dsPIC30F5011/5013 Family Silicon Errata and Data Sheet Clarification

The dsPIC30F5011/5013 family devices that you have received conform functionally to the current Device Data Sheet (DS70116J), except for the anomalies described in this document.

FIGURE 1: dsPIC30F5011/5013 DATA EEPROM

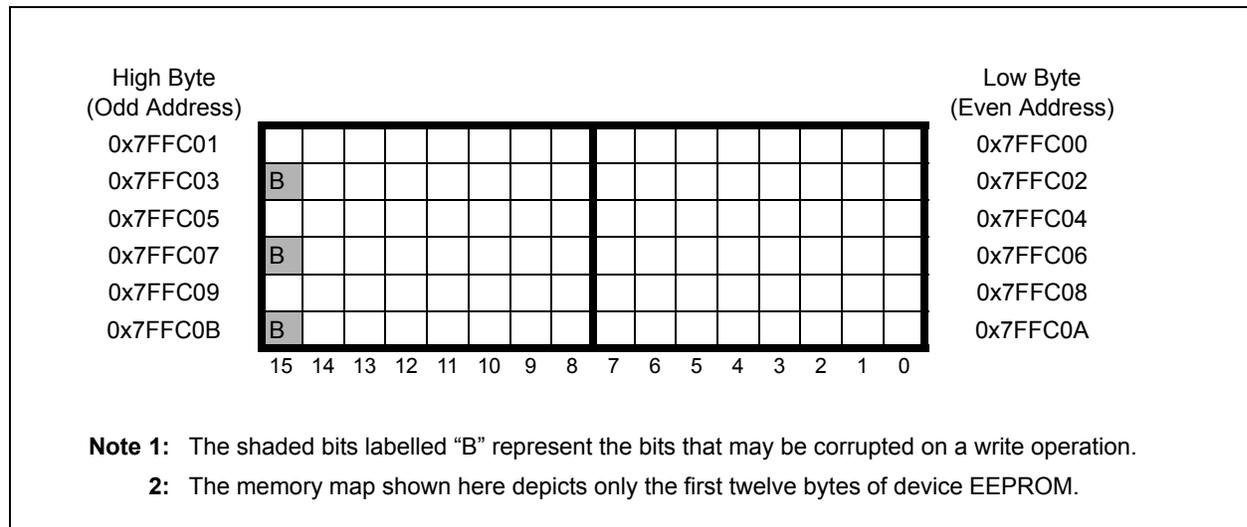
Figure 1 shows the first twelve bytes in data EEPROM and indicates the affected bits.
